CABINET MEMBER FOR TRANSPORT – 28 JULY 2011**BURFORD ROAD CYCLEWAY, CARTERTON**

Report by Deputy Director for Environment & Economy (Highways & Transport)

Annex 4 - Consultation Responses – Formal Consultation Proposed Design, June 2011.

Annex 3 - Scheme Design available on separate sheet.

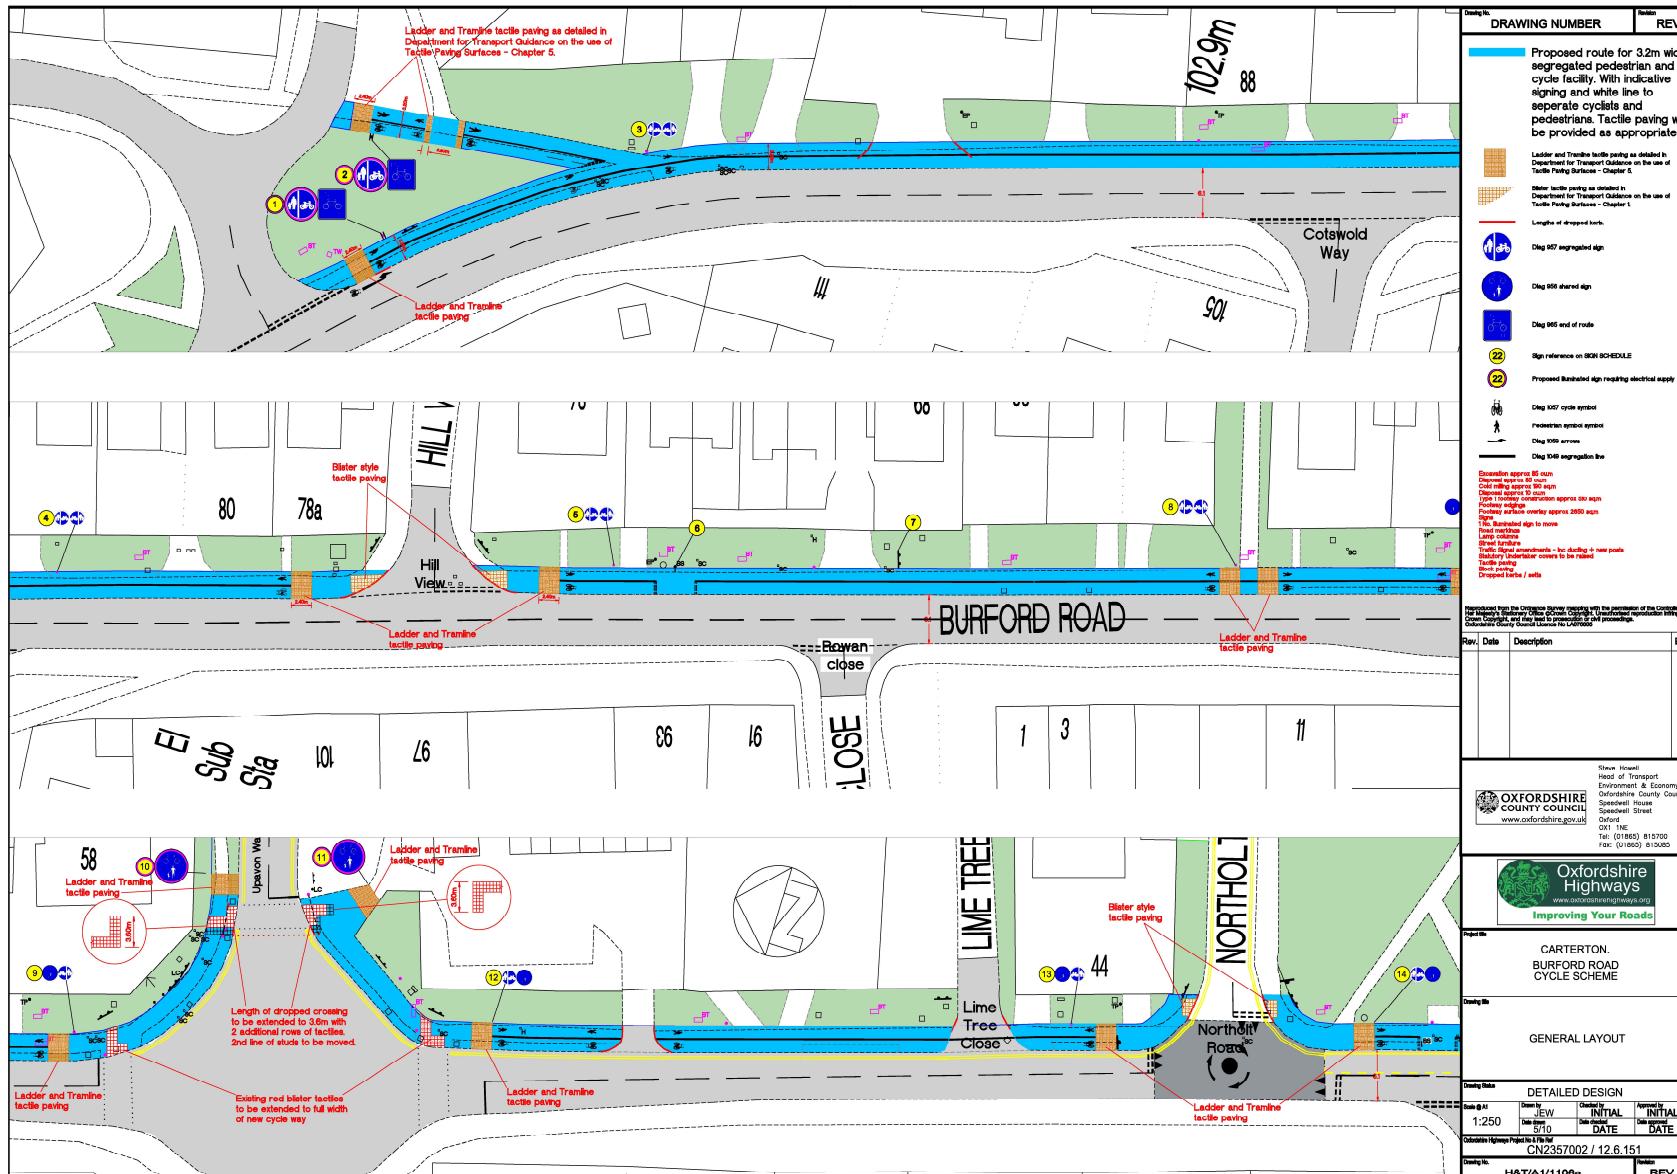
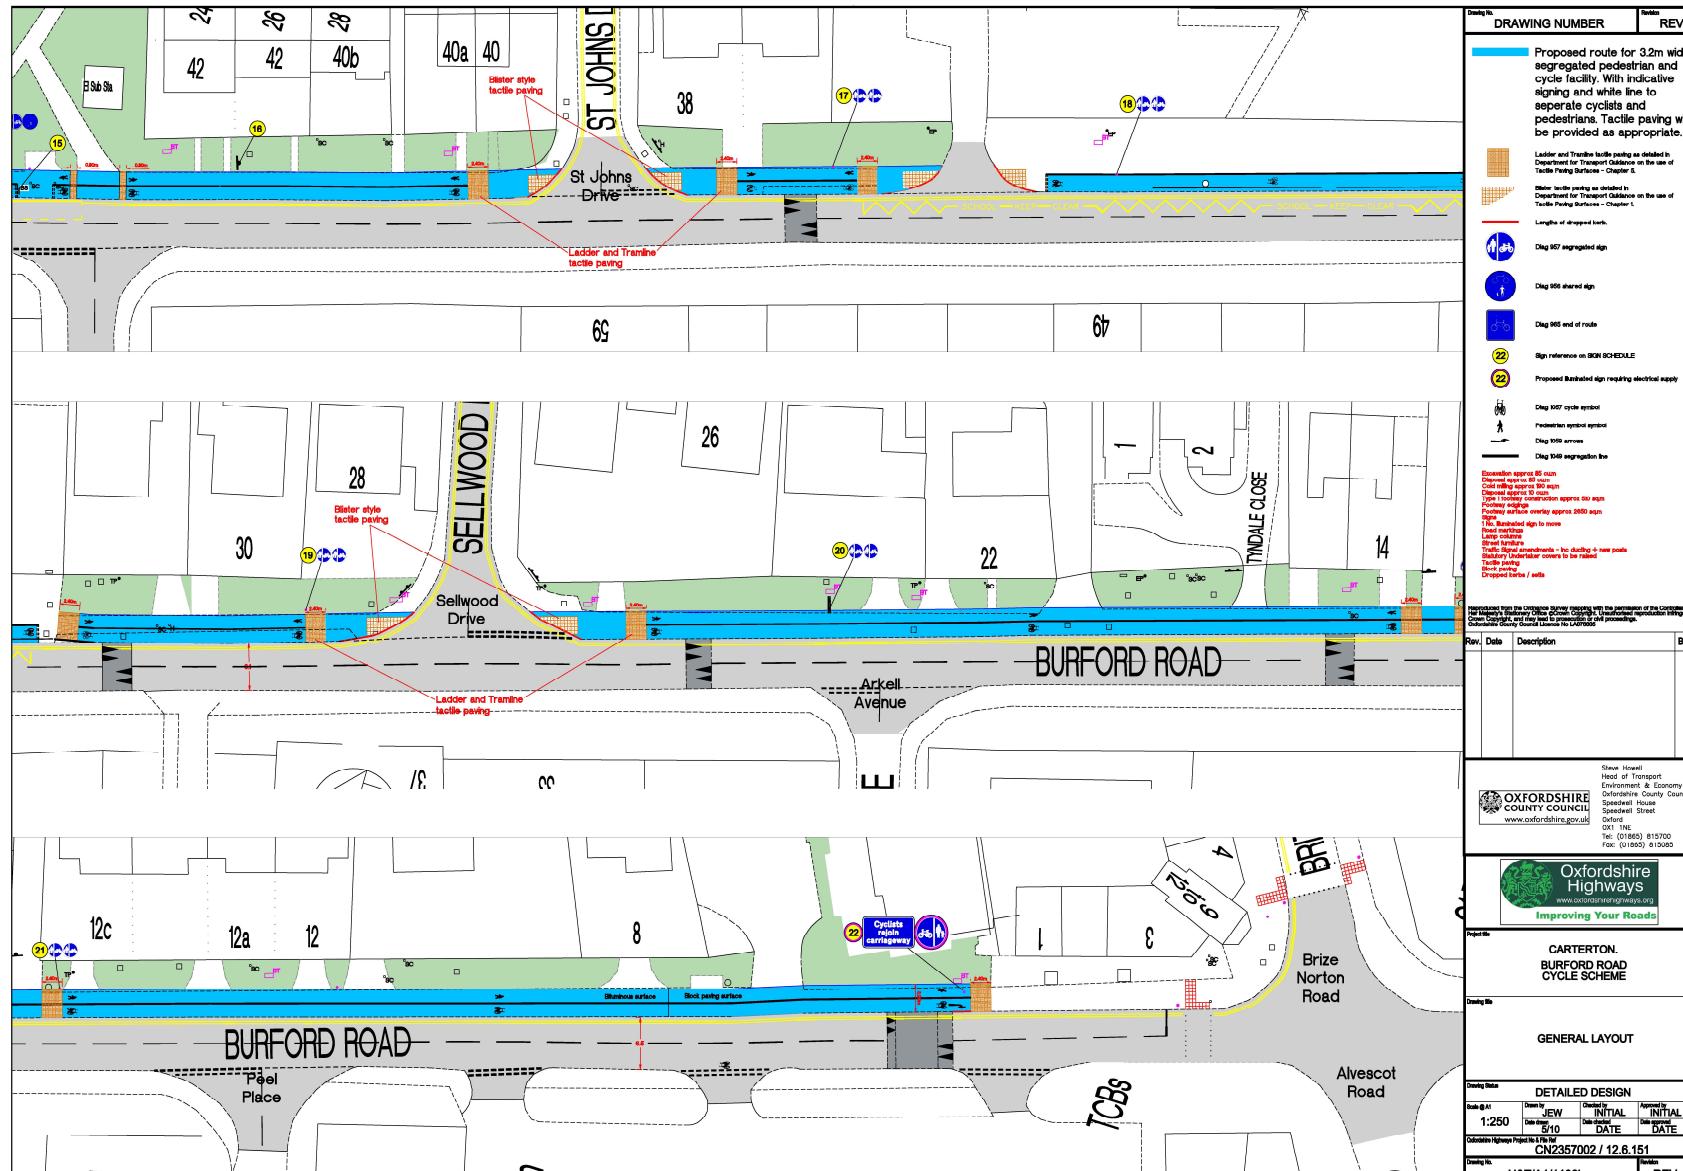
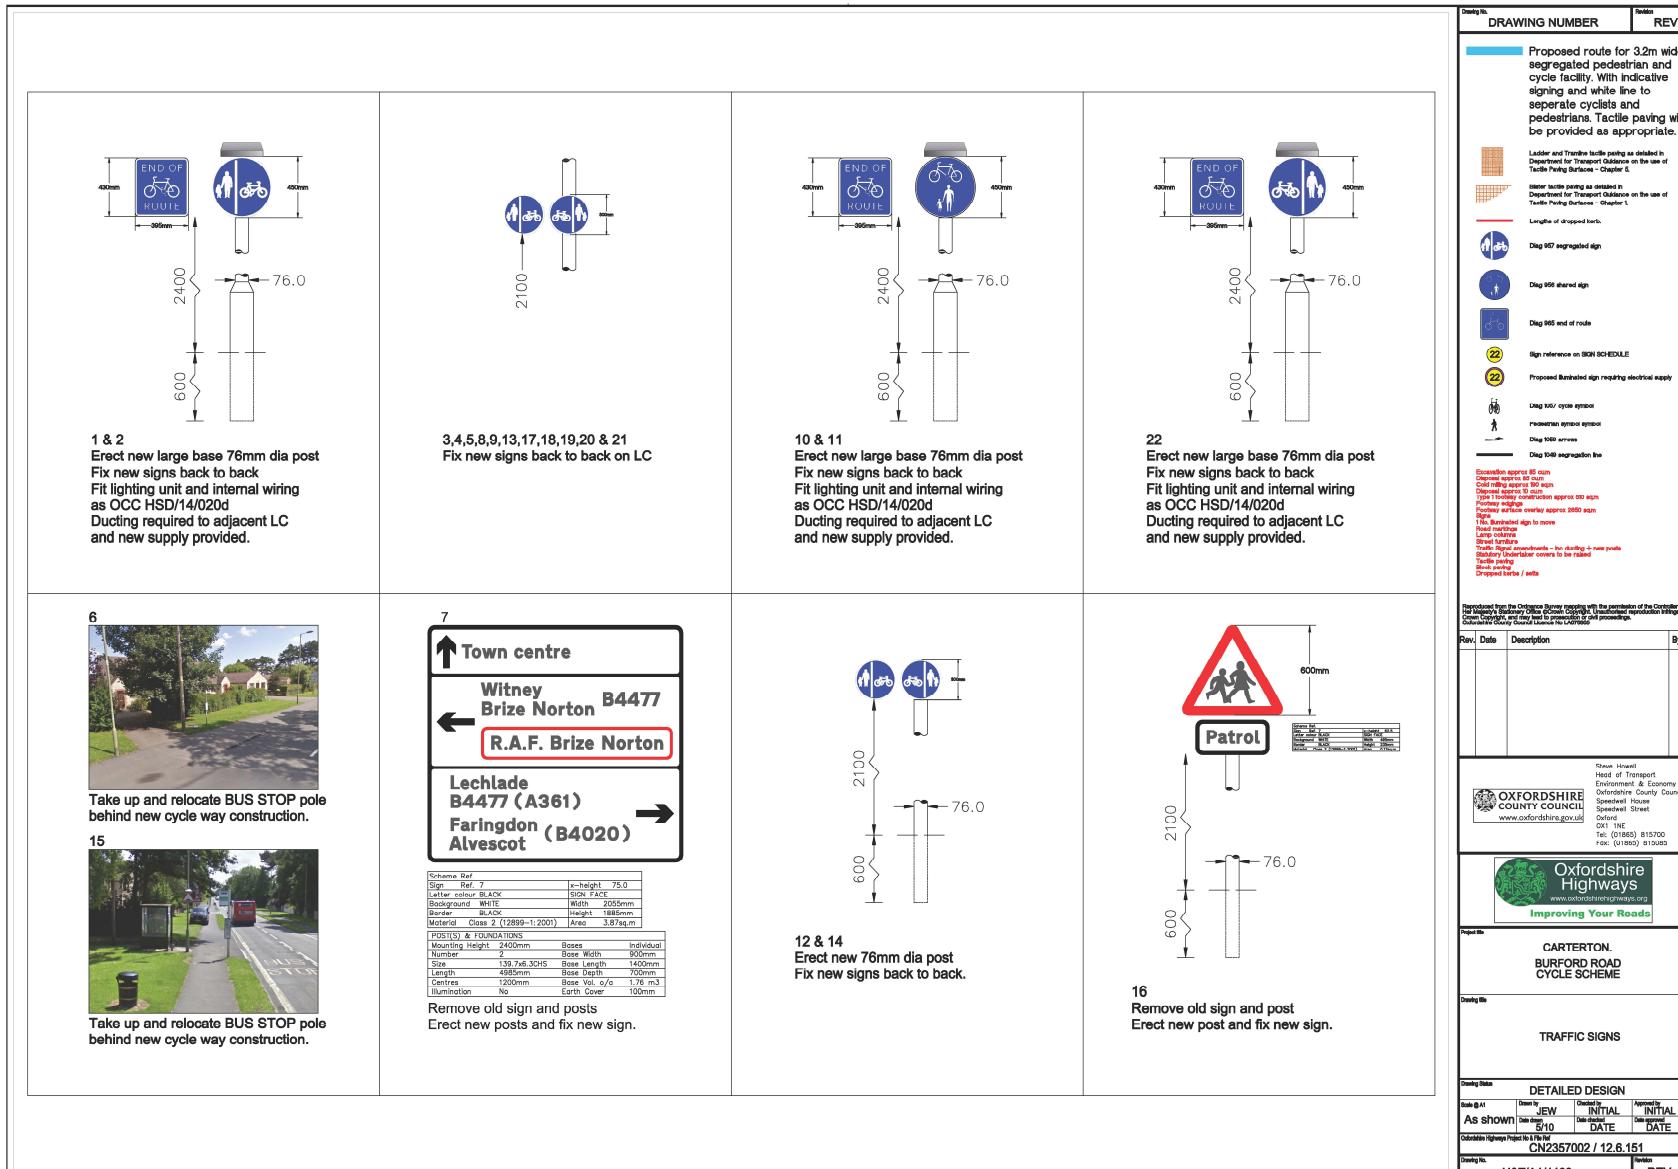
| | Respondent | Support proposal | Comments | Officer Comments |
|----|---|------------------|---|---|
| 1. | Resident Burford Road | Unknown | <ol style="list-style-type: none"> 1. Requested barriers be installed to ensure people coming out of the footpath from Church View do not cut across the grass verge, as they cannot be seen when exiting the adjacent driveway. 2. Requested enforcement of the cycleway, as witnessed a lack of respect of cyclists for pedestrians. | <ol style="list-style-type: none"> 1. To be considered for inclusion in detailed design. 2. Noted |
| 2. | West Oxfordshire Sustainable Transport Forum. | Yes | <ol style="list-style-type: none"> 1. Requested that the design is altered to include tabled/flat humped traffic calming at side roads, with the give way lines in side roads placed behind the table to give priority to pedestrians and cyclists across the junction instead of road traffic. The group felt the benefits are: <ul style="list-style-type: none"> • Such crossings improve movement for pedestrians and cyclists. • Cyclist priority is recommended for side roads with <100 vehicles per hour, and should be considered for 100-200 vehicles. • Clear signage and markings are essential, so that motorists are aware. • It can be helpful to set the crossing back from the kerb ("bent out") but this is not essential. • Humped crossings ("side raised entry treatments") are preferable, though again, not essential. | <ol style="list-style-type: none"> 1. Agree this has merit. However to provide this would significantly increase the cost of the scheme. It is not recommended that they be included in the scheme design. |
| 3. | CTC Representative | Yes | <ol style="list-style-type: none"> 1. Suggests the two-way cycling lane of 1.6m is too narrow. 2. Feels the scheme would be simplified if it were not segregated. 3. Suggests cycles should have priority at all road junctions. 4. Concerned about the design at the end of route. Rejoining the carriageway at the southern end by the traffic light controlled junction with Brize Norton and Alvescot Roads will be a difficult manoeuvre to execute (looking over shoulder) and it puts the cyclist at quite a disadvantage. Suggests several design options: a) Continue the path to an ASL box at the lights and provide some protection to the cyclist rejoining the carriageway. b) Paint a Give Way line for south bound traffic in front of the raised table and allow cycles to leave and join the | <ol style="list-style-type: none"> 1. Noted. 2. Noted. 3. As stated in response to respondent 2. 4. Consider for inclusion in detailed design. |

| | Respondent | Support proposal | Comments | Officer Comments |
|----|-----------------------|------------------|--|--|
| | | | <p>path from the top of the raised table.</p> <p>5. Requested the white centre line of the carriageway be removed from the existing tabled junction.</p> <p>6. Queried the white circle on the layout plan to the right of reference 18.</p> <p>7. Cycles join the cycleway at the northern end of Burford Road by Swinbrook road at an acute angle. Will the dropped kerb be flush? Wet dropped kerbs with even small lips will take the front wheel away at such angles. Suggests a) Moving the Give Way line of Swinbrook Road back so cycles can access the cycleway "in line". b) Extend the length of flush kerb to 5m.</p> <p>8. Cycles rejoining the carriageway heading north on Shilton Road are at a significant disadvantage. It's not clear how cyclists will choose to perform this manoeuvre. Suggests a raised table crossing be installed on Burford Road near reference 3. This would be a useful traffic calming feature as well as a useful crossing point for cyclists and pedestrians.</p> | <p>5. Noted.</p> <p>6. The white circle is a litter bin. Care will be taken to ensure this is not an obstruction.</p> <p>7. Consider for inclusion in detailed design.</p> <p>8. Consider for inclusion in detailed design.</p> |
| 4. | Road Safety Team, OCC | Yes | <p>1. Would recommend consideration of providing 'give way' markings for cyclists at side road junctions. These should be provided for both directions of travel to ensure cyclists give way to side road traffic.</p> <p>2. If there are bus stops it can be helpful to provide give way markings for both directions to help highlight for cyclists the need for caution when passing through the stop area.</p> <p>3. There are however one or two locations where the proposed markings seem possibly a little over-provided (e.g. near the Swinbrook Road junction).</p> <p>4. Providing humps across the side road junctions does appreciably improve the amenity of the route (for both pedestrians and cyclists). Recommend that these be considered, even if as a 'retro fit' so as not to delay the scheme.</p> | <p>1. Consider inclusion in detailed design.</p> <p>2. Noted</p> <p>3. Noted</p> <p>4. Agree this has merit. However to provide these would significantly increase the cost of this scheme and it is not recommended that they be included in the scheme design.</p> |

| | Respondent | Support proposal | Comments | Officer Comments |
|----|--|-------------------------|--|--|
| 5. | Disability and Equality Adviser, OCC | Unknown | 1. Provide a raised thermoplastic separating line or different colour/ texture surfaces to aid identification and use. | 1. Consider inclusion in detailed design. |
| 6. | WODC Planning Officer. | Yes | 1. Has consideration to priority crossing side roads been looked into? 2. Is segregation with a white line down the middle necessary? The route could still be signed and marked as a shared pathway. 3. In relation to signage we should be aiming to reduce the amount of street clutter to a minimum. | 1. As stated in response to respondent 2. 2. Initial consultation favoured segregated use. 3. Noted. |
